Our Ref: GRM/P10350/LR.01

RE: Planning Response to Proposed Development at Cliff Hill, Cumberworth Lane, Denby Dale

The following document has been prepared for the planning committee in response to queries related to the drill and grout treatment works and Ground Stabilisation Remedial Strategy prepared by GRM Development Solutions (ref GRM/P10350/MRS.1 Rev A, dated July 2023).

CLIENT:	Urban Group (York) Ltd
PROJECT:	Cliff Hill, Cumberworth Lane, Denby Dale, Huddersf
TITLE:	Proposed Drill and Grout Treatment Grid

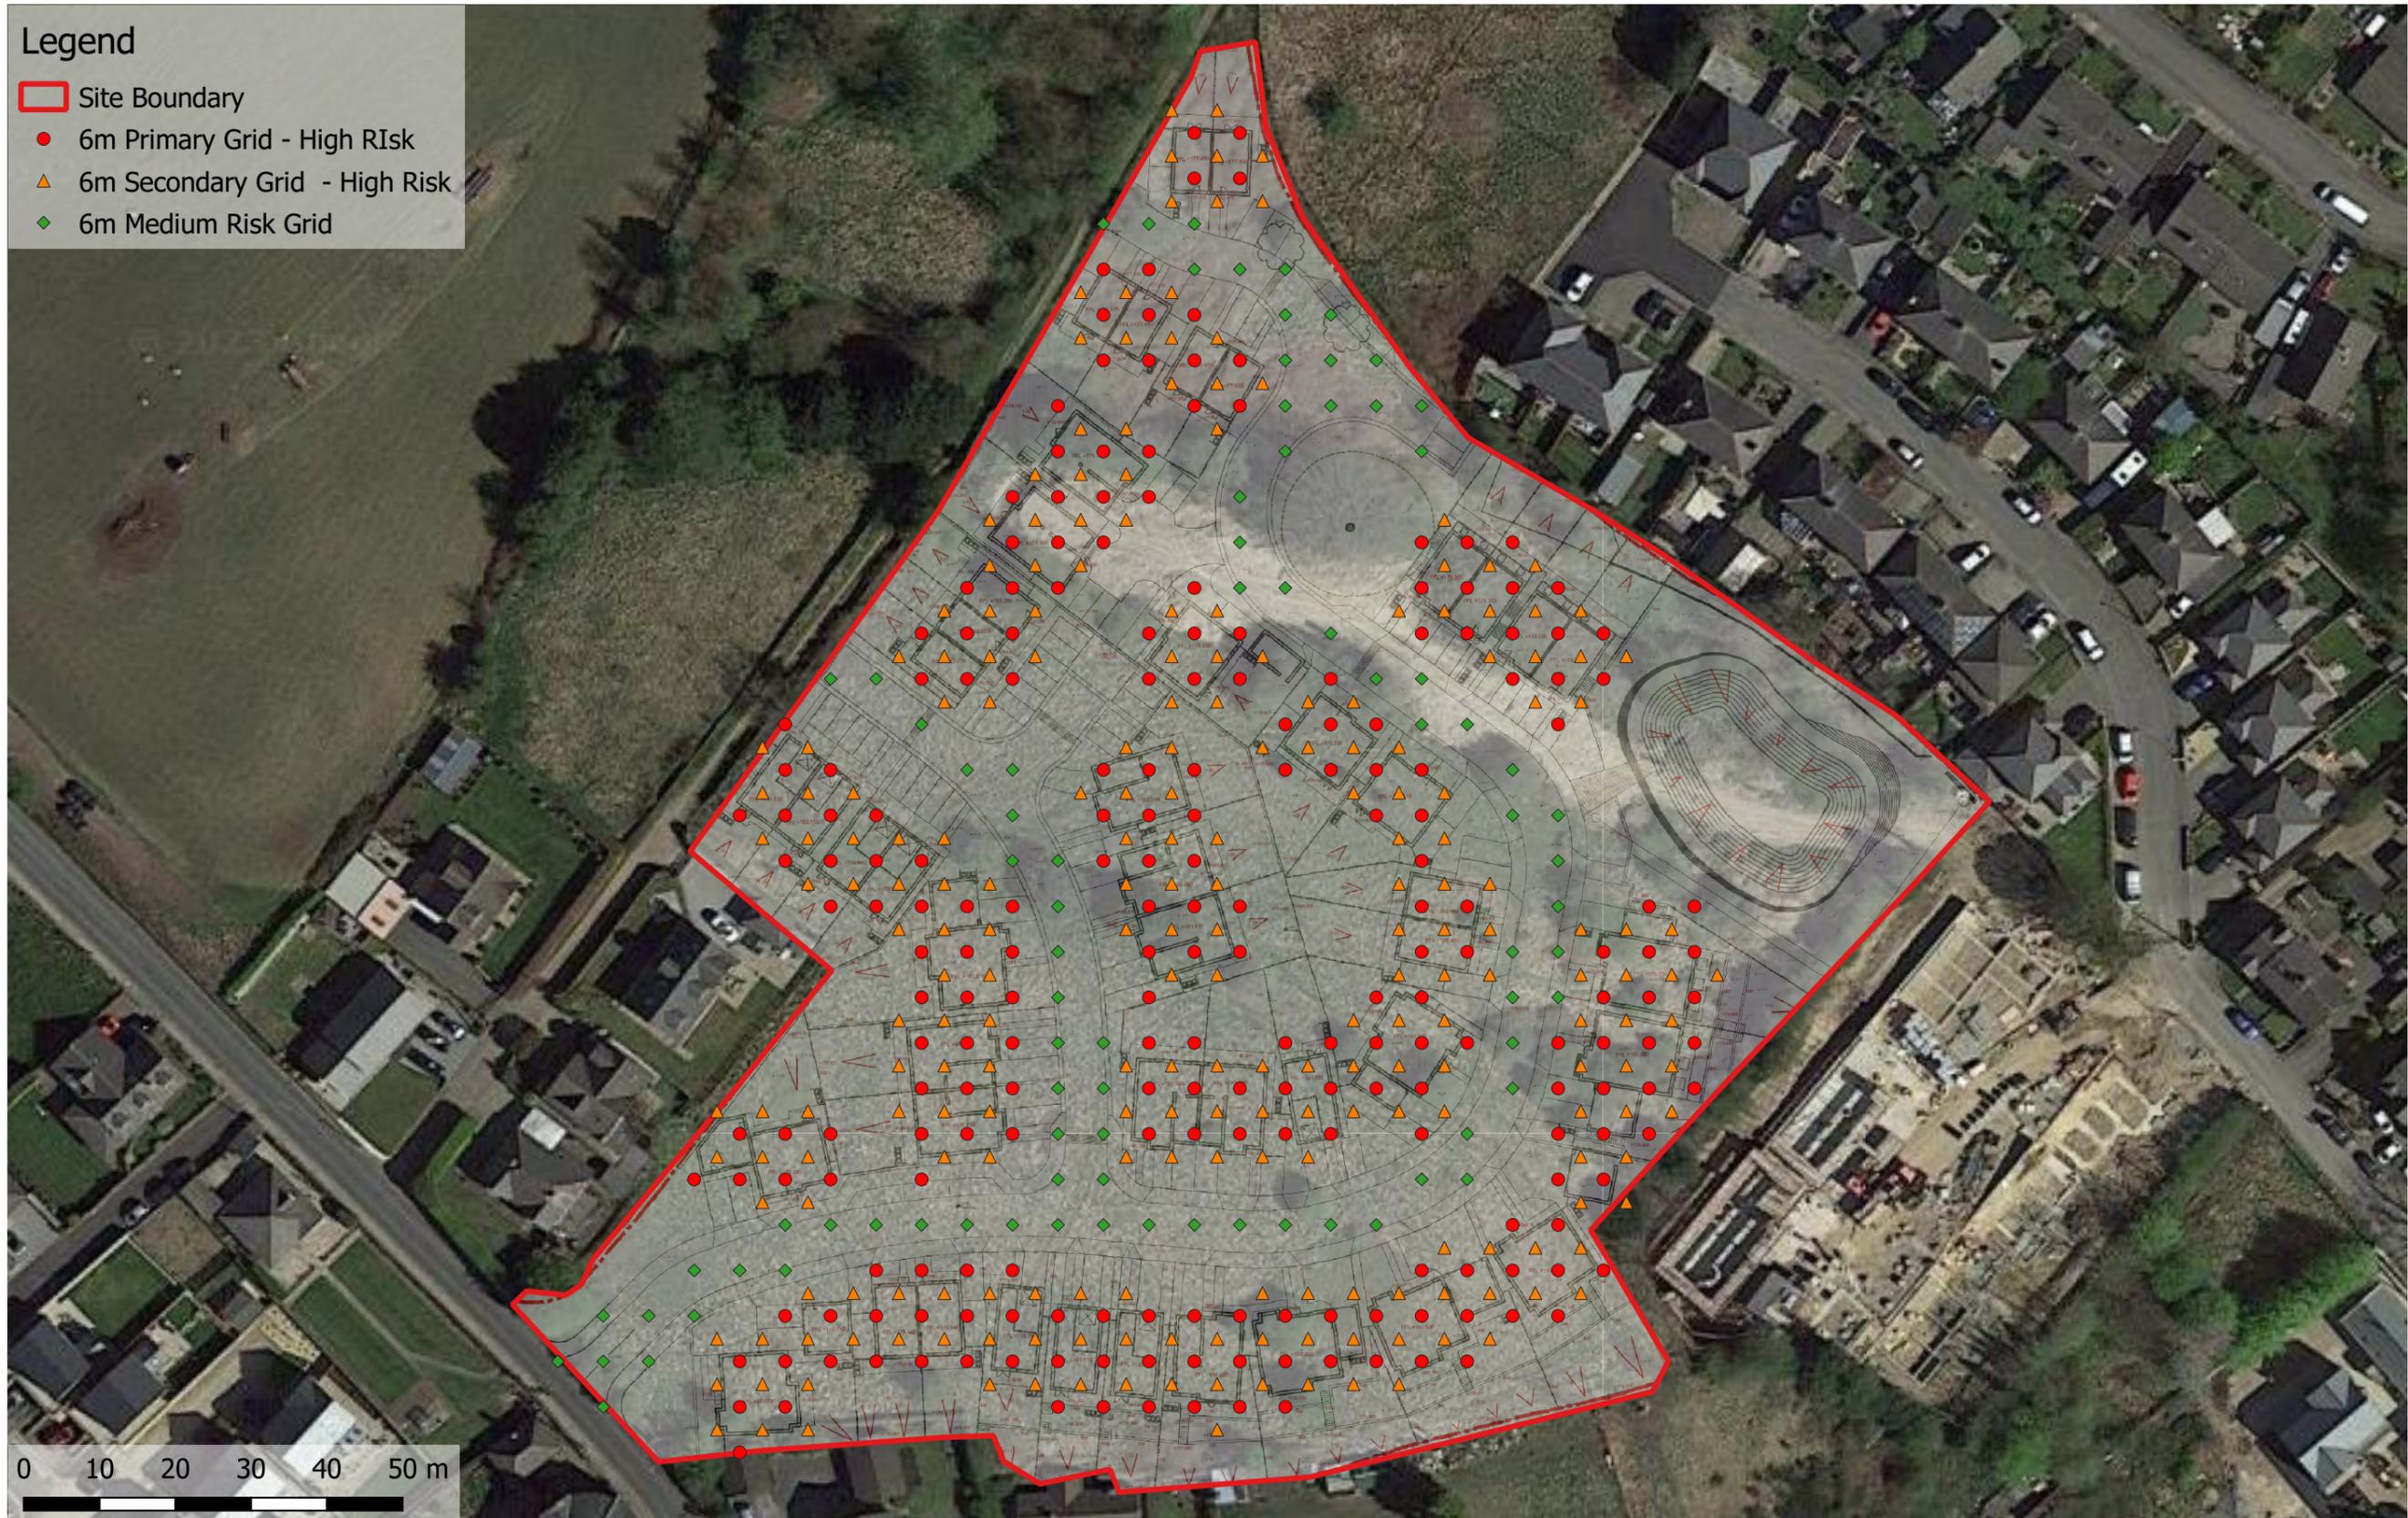
The remedial strategy document and proposed treatment grid (attached), highlights approximately 300no primary holes and an additional 250no secondary holes. The treatment holes are anticipated to be c.20m deep. Using an approximate volume of 3m³ of grout per treatment hole a **volume of 1650**

A proposed treatment grid has been produced, based on zoning the development into risk categories. Gardens and areas of public open space are considered to be at low risk and no treatment boreholes have been proposed in these areas. Estate roads are considered to be moderate risk with 6m primary treatment holes being completed, additional treatment holes may be required subject to grout takes. Residential dwellings have been assigned a high risk and will be treated on a primary 6m and secondary 3m treatment grids. The proposed treatment grid has been appended to this document.

tonnes has been calculated. This volume will consist of a mix of pulverised fuel ash (PFA), Ordinary Portland Cement (OPC) and sand. This figure is likely to change as works progress and more information becomes available. A more refined estimate may be calculated following additional borehole investigations.

Large tracked rotary rigs (similar in size to some 360 excavators) are used to drill the treatment holes. A mixing plant is used to prepare the grout. Rubber grout pipes will be linked from the mixing plant and the grout injected into the ground methodically at each treatment borehole position.

- Depths of the target seams are to be established through ground investigation. Treatment is not required where the seam is covered in competent rock, which is at least 10 times the thickness of the worked seam.
- Primary grouting holes are drilled on a 6m grid with secondary holes below and in the immediate surrounds of proposed new structures on an approximate 3m grid.
- Grout is pressure injected to the depth of the coal workings via a temporary steel casing socketed into the rockhead.
- A grout mix of cement (OPC) and pulverised fuel ash (PFA) would be used. If excessive voiding is encountered, the use of sand will be included in the grout mix as a filler.
- Tertiary holes may be required to check and prove grouting success.
- Grout is injected into the treatment holes and pressurised to the surface, to ensure full depth reinstatement.
